**Request for Additional Information 564, Supplement 3**

**Application Title: U. S. EPR Standard Design Certification - Docket Number 52-020**

**Review Section: 08.02 - Offsite Power System**

**Question 08.02-8:**

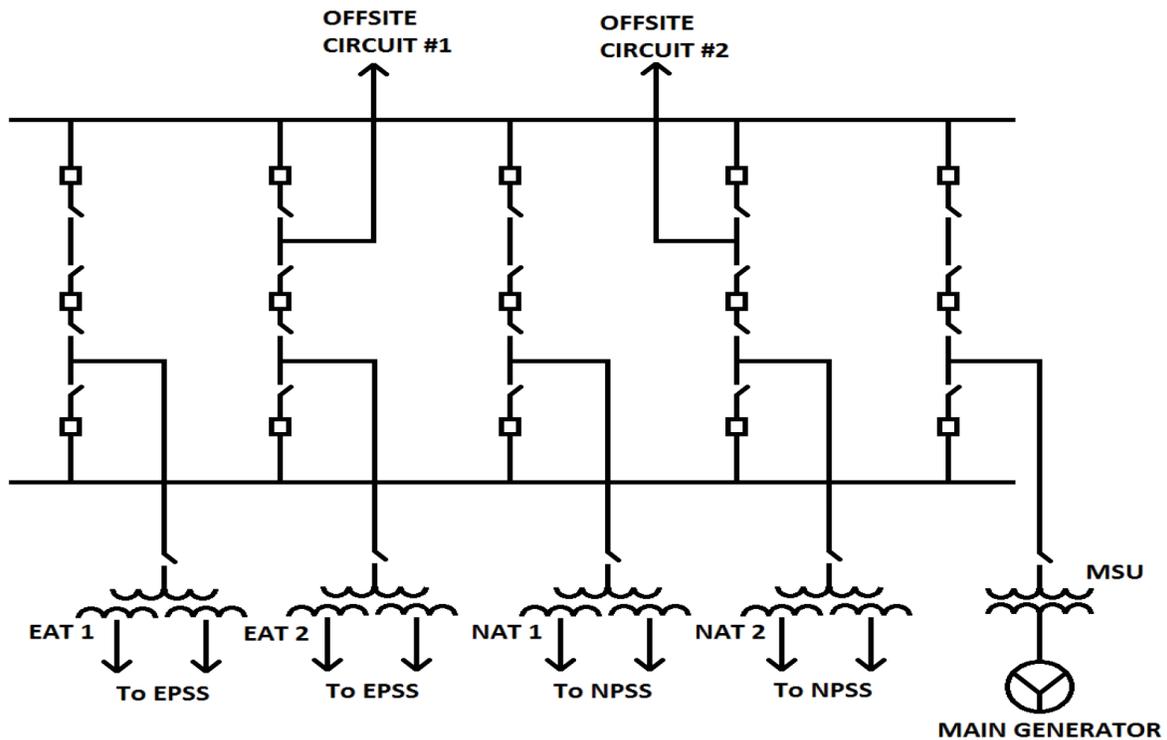
- Describe the protection scheme design for important to safety buses (31-34BDA) to detect and automatically respond to a single-phase open circuit condition or high impedance ground fault condition on credited offsite power circuits.
- If the important to safety buses are not powered by offsite power sources during at power condition, explain how the surveillance tests (e.g., SR 3.8.1.1) are performed to verify that a single-phase open circuit condition or high impedance ground fault condition on an off-site power circuit is detected.
- Describe the plant operating procedures including off-normal operating procedures, specifically calling for verification of the voltages on all three phases of the ESF buses.

The four Class 1E Emergency Power Supply System (EPSS) Buses 31-34BDA of the U.S. EPR design are powered from two, 25 MVA, 3-winding Emergency Auxiliary Transformers (EAT), 30BDT01 and 30BDT02. The three windings of each EAT are connected Wye; the primary, high-voltage side neutral is solidly grounded, and the two secondary, low-voltage side neutrals are each high-impedance grounded. Although each EAT has the capacity and capability to power all four EPSS buses (31-34BDA) under all design basis conditions, the normal operating configuration is for each EAT secondary winding to power a single EPSS bus.

The EATs are powered by dedicated off-site feeds that are not used for powering normal operation plant loads such as RCPs, Main Feedwater Pumps, etc. The Normal Auxiliary Transformers (NATs) supply the normal operations plant loads and have their own dedicated off-site power feeds. The U.S. EPR electrical system configuration also assures that should a loss of phase occur on one of the off-site feeds, the emergency buses and associated safety equipment powered by the second off-site feed are unaffected.

The U.S. EPR electrical system off-site power supply design provides a stable, dedicated and voltage regulated power source for the Emergency Buses. This configuration presents a somewhat unique relaying design challenge when trying to monitor for loss of a single off-site power supply phase due to the light loading of the EATs during normal at-power operation. This normal

operating configuration maintains the EATs very lightly loaded, roughly estimated at 5 to 8 MVA each.
